Office Action Summary	Application No.		Applicant(s)	
	10/024,570		JAINEK, HERBERT	
	Examiner		Art Unit	
	Mr. Terry K. Cecil		1723

DETAILED ACTION

Fig. 2

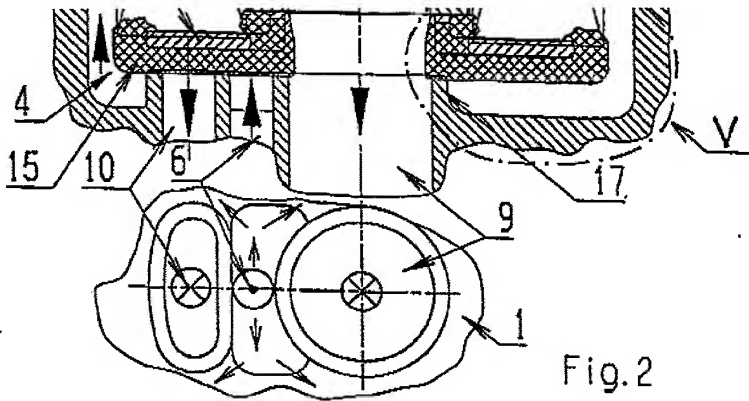
As shown by the arrows in figure 2 reproduced below, fluid to be filtered enters channel 6 and then flows radially outward and into the pre-filt chamber 7 that extends between the filter element and the chamber.

However, '367 does not teach the first seal assembly to be disposed in front of the inlet (downstream of) to reduce back flow of unfiltered liquid from the unfiltered side of the filter element to the inlet and of the filter arrangement during operation. Gandini teaches such a seal that includes an antidrainback member 28 [as in claim 9] that extends radially outward from the radial edge of the filter element [as in claim 6] and rests against the housing (this part of the housing can be considered a "stop" [as in claim 7]). It is considered that it would have been obvious to one ordinarily skilled in the art at the time of the invention to have the member 28 of Gandini to extend from the disc element 4 to the housing in the area of the arrows of figure 2, since Gandini teaches the benefit of preventing the filter from running empty (col. 2, lines 7-8).

This would prevent the filter from draining after the engine is shut off in order to avoid a lag time for filtered fluid when the engine is restarted.
